**Attachment B: Records of Changes to Final Design Submission
Packages**

North Texas OAPM Design Package

DFW SIDs, HUDAD, HRPER, KATZZ, ALIAN and WSTEX DFW RNAV SIDs

RECORD OF CHANGE

Figure 2. Proposed WSTEX RNAV SID and PODDE THREE RNAV SID (Will replace Figure 3 in the FD)

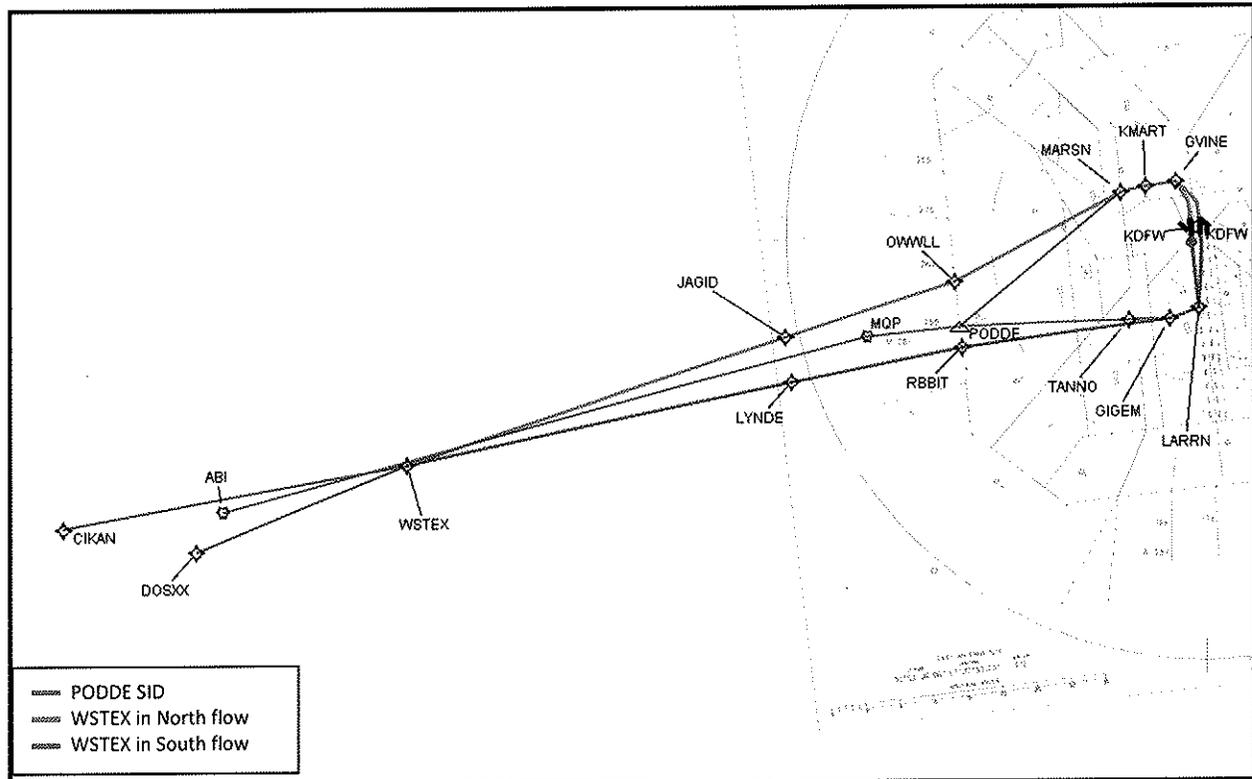
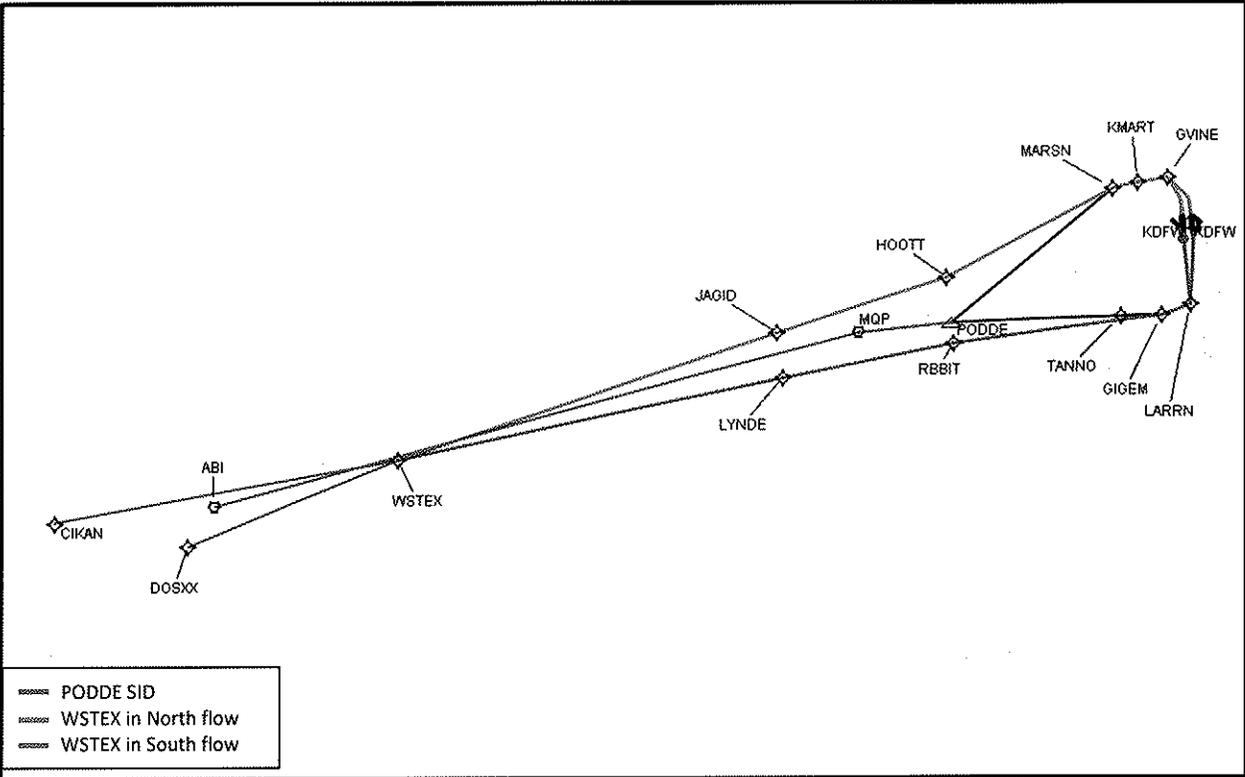
On the ALIAN and WSTEX RNAV SIDs, OWWLL waypoint was renamed HOOTT waypoint due to a similar sounding waypoint on an adjacent procedure.

Figure 2 below replaced Figure 3 in the FD.

Figure 6. Proposed HUDAD RNAV SID and FERRA FOUR RNAV SID (Will replace Figure 5 in the FD)

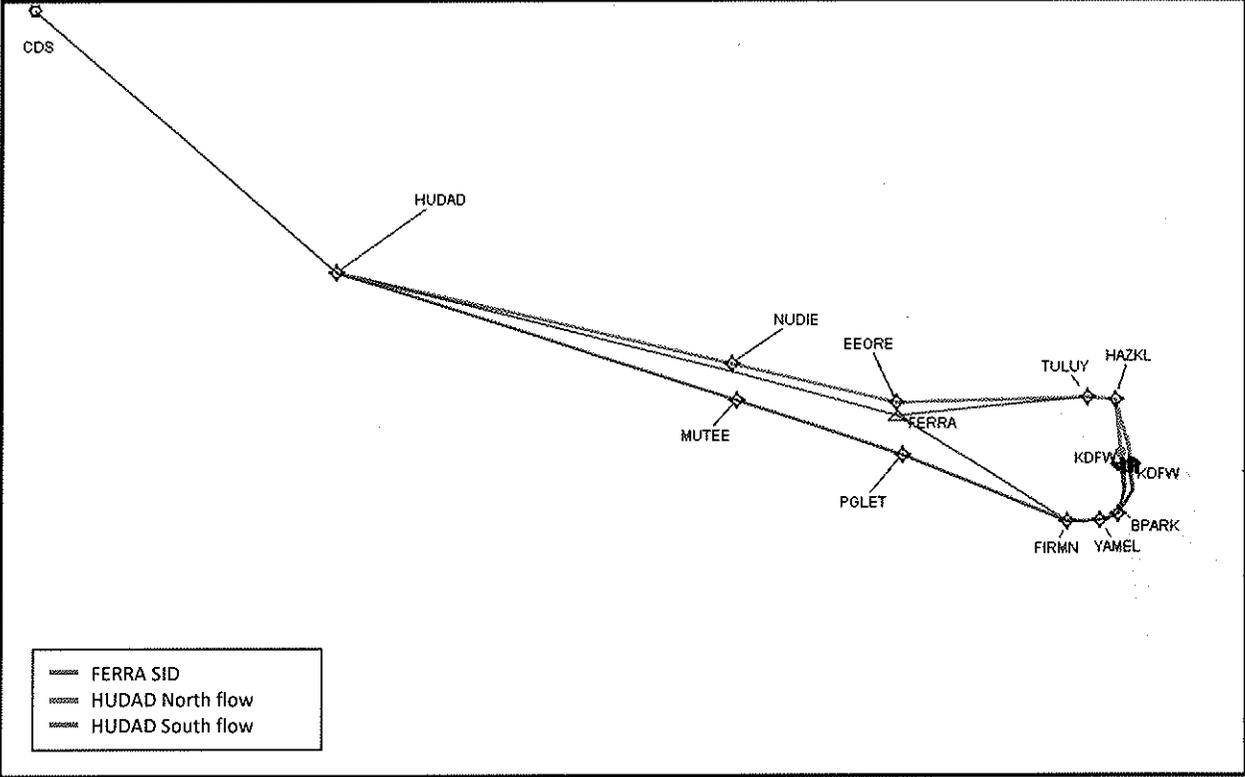
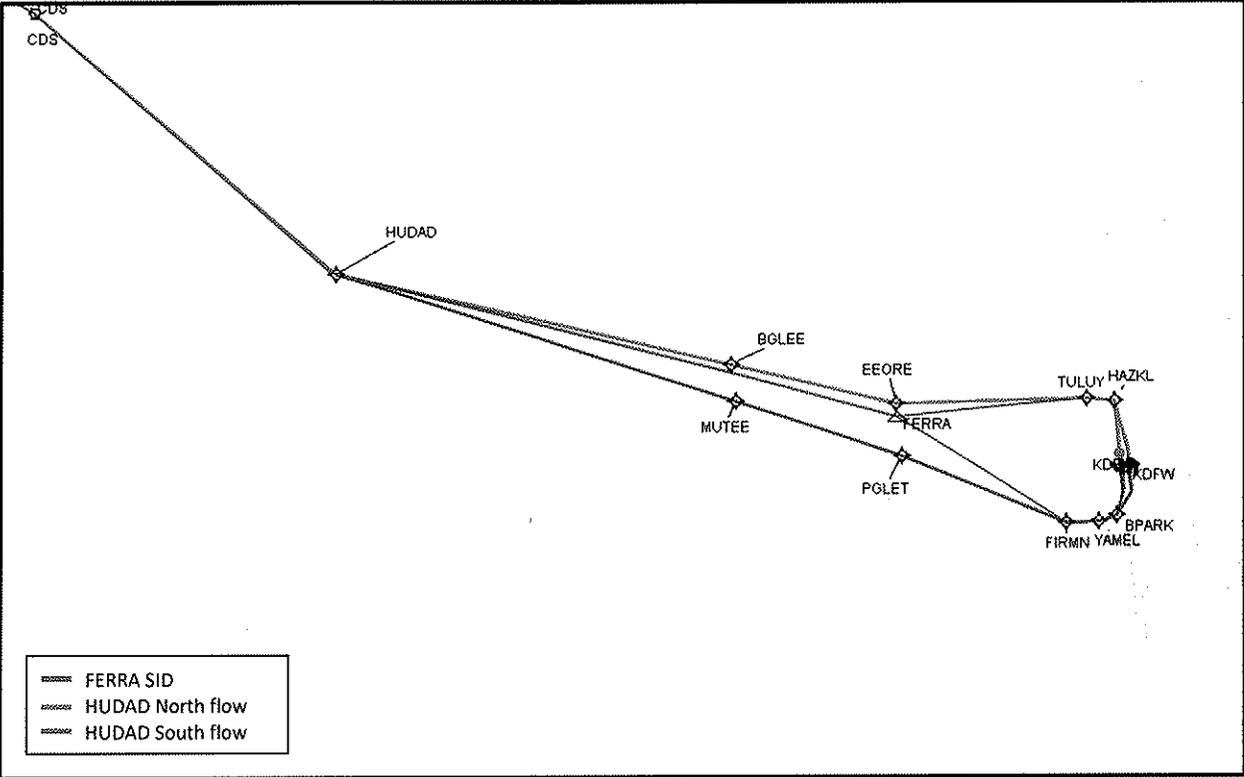
On the HUDAD RNAV SID, NUDIE waypoint was renamed BGLEE waypoint due to waypoint name reservation availability.

Figure 6 below replaced Figure 5 in the FD.

Figure 2. Proposed DARTZ FIVE RNAV SID (Will replace Figure 2 of FD)

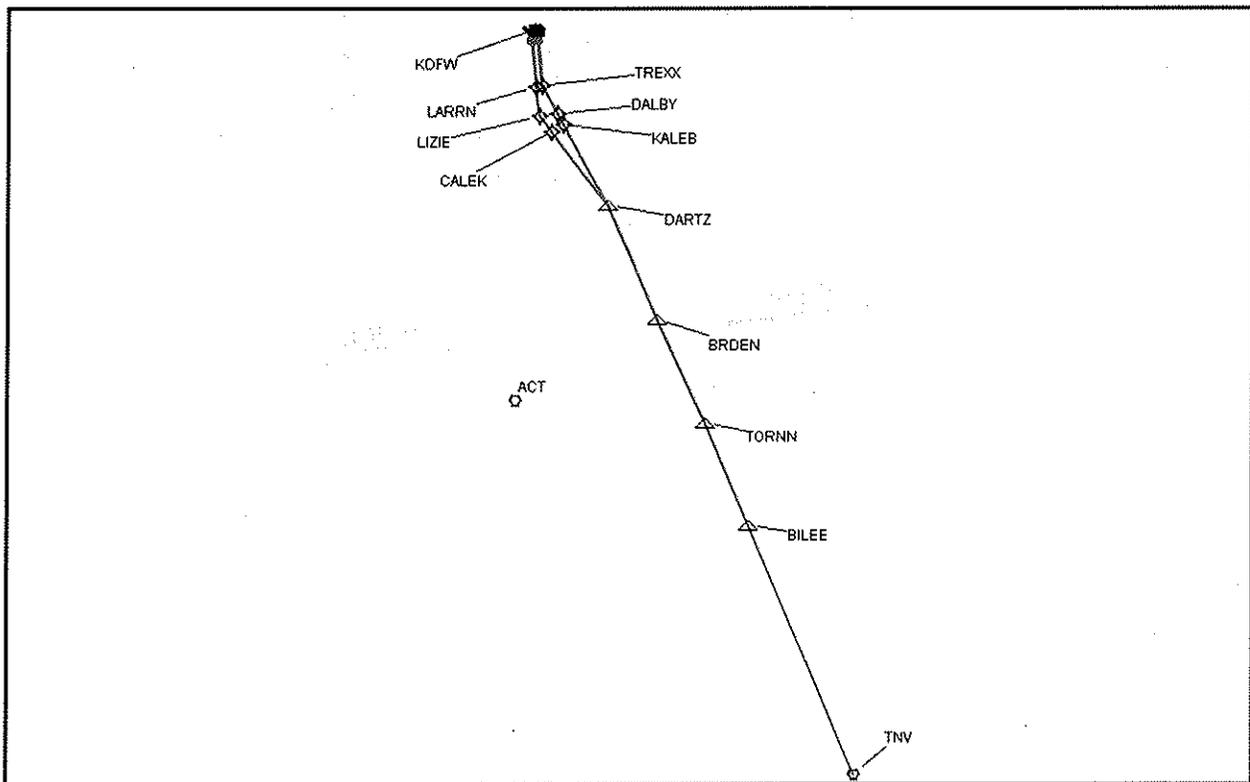
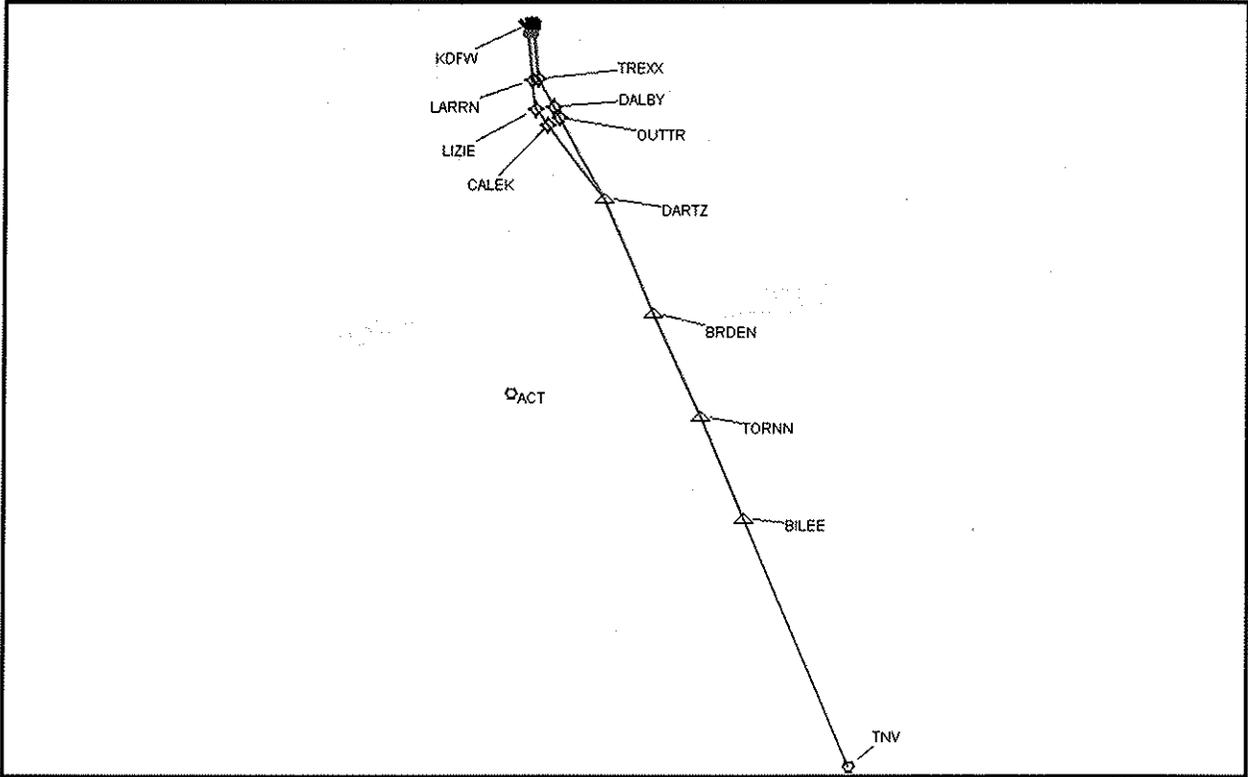
On the DARTZ RNAV SID, KALEB waypoint was renamed OUTTR waypoint due to waypoint name reservation availability.

Figure 2 below replaced Figure 2 in the FD.

Figure 2. Proposed BACHR RNAV STAR and KNEAD STAR (Will replace Figure 3 of PFD)

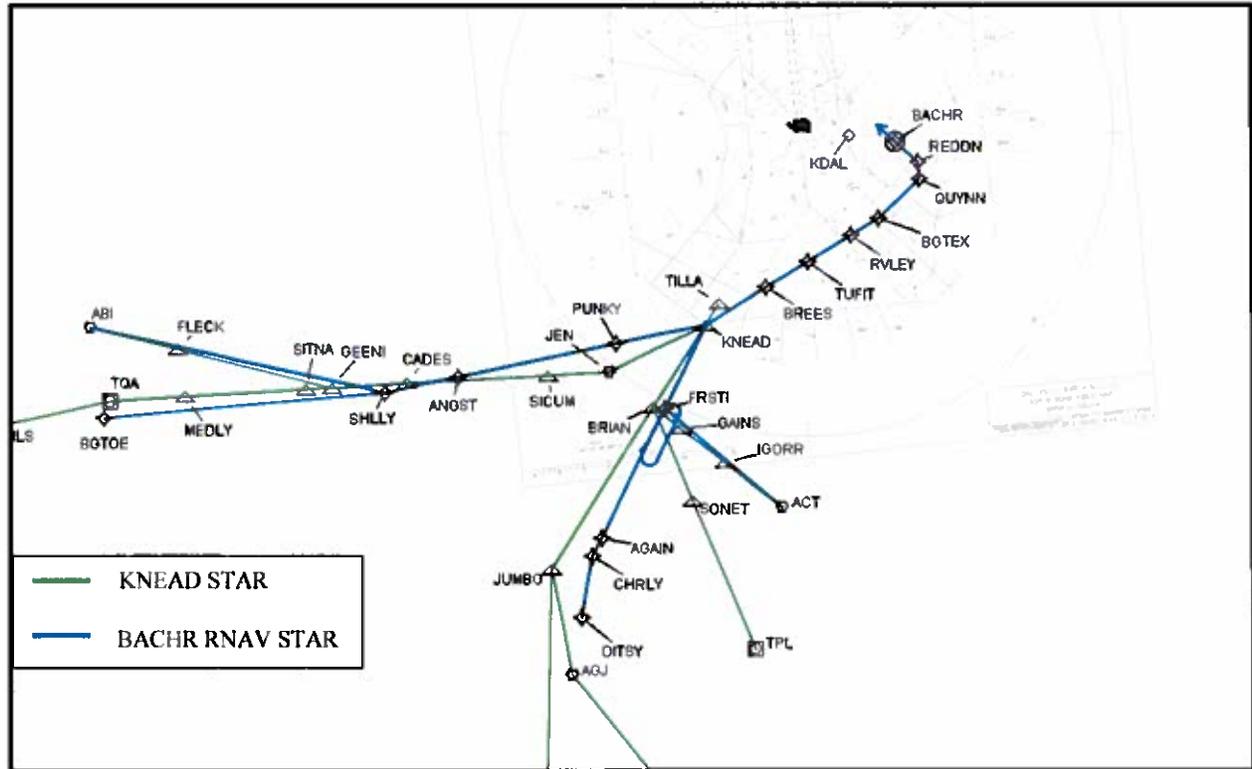
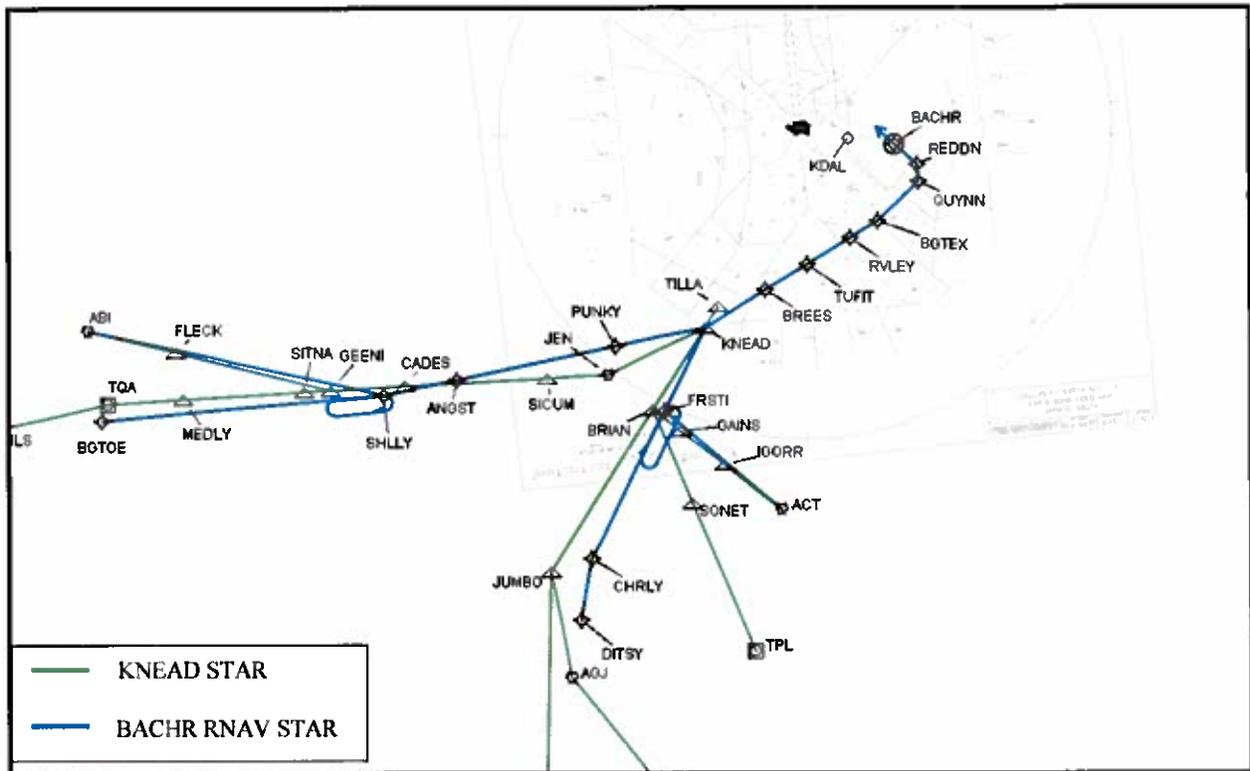
On the BACHR RNAV STAR in Figure 3 a holding pattern was added to SHLLY waypoint, and the AGAIN waypoint was deleted.

These changes are due to errors on the TARGETS files initially used.

Figure 2 below replaced Figure 3 in the PFD.

Figure 2. Proposed BOOVE and SOCKK RNAV STARS and JEN STAR (Will replace Figure 3 of FD)

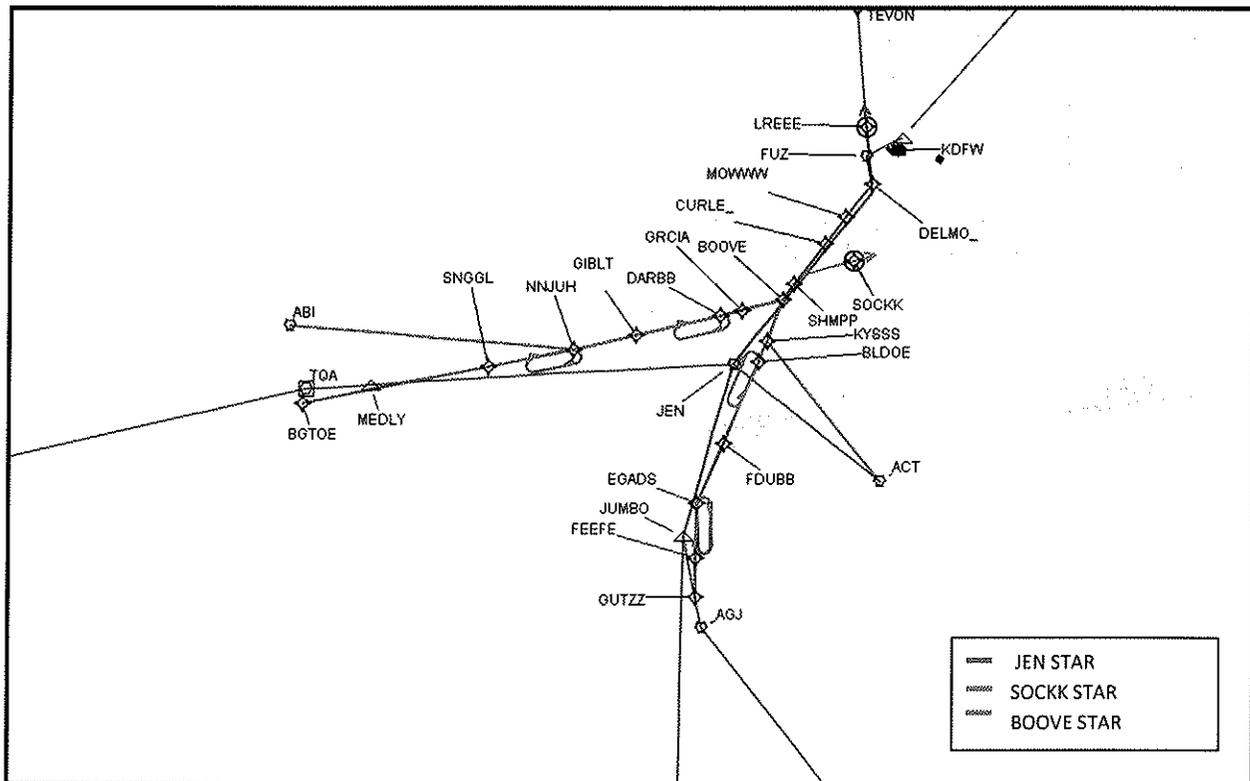
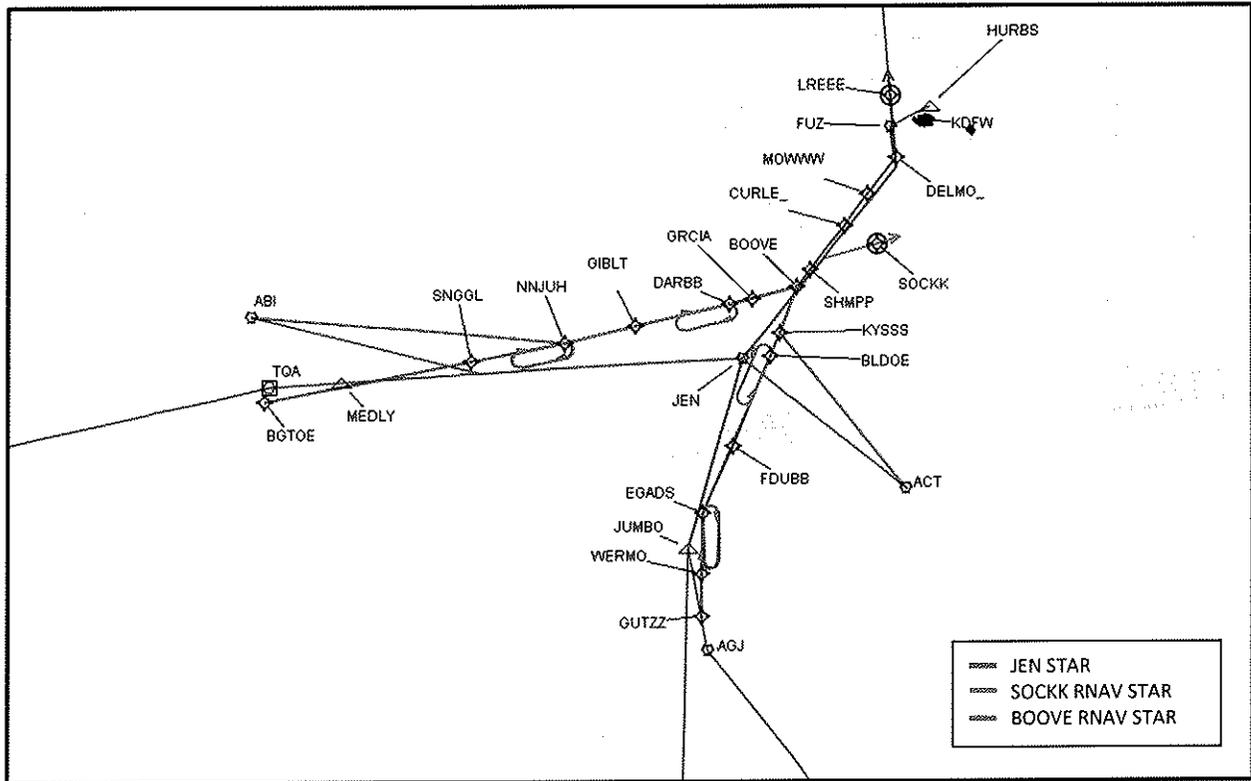
On the SOCKK RNAV STAR, FEEFE waypoint was renamed WERMO waypoint due to waypoint name reservation availability.

Figure 2 below replaced Figure 3 in the FD.
